JFAS Aviation Safety News

Date 2026.1.12 ASN60-03

Erroneous Takeoff from HND/RJTT RWY05

<Figure 1: Haneda Airport Layout and RWY 05 where the erroneous takeoffs occurred>

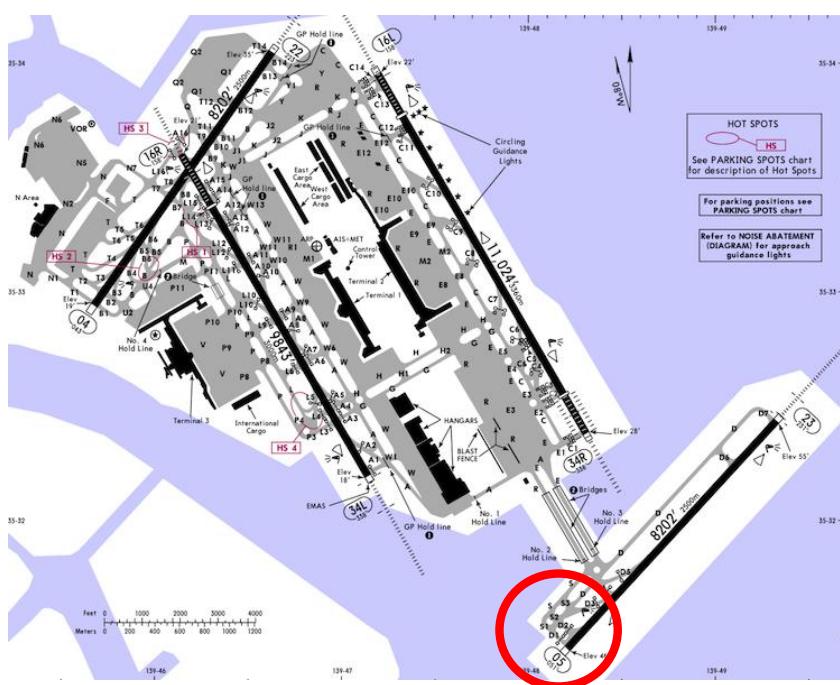
- Aircraft taking off from RWY05 will taxi from TWY D1 or D2, with the specific taxiway assigned by ATC.
- Both aircraft that damaged Runway Lights (RL) while initiating takeoff roll had entered the RWY from RWY D2, suggesting that factors potentially leading to pilot misperception may exist when entering the RWY from TWY D2.
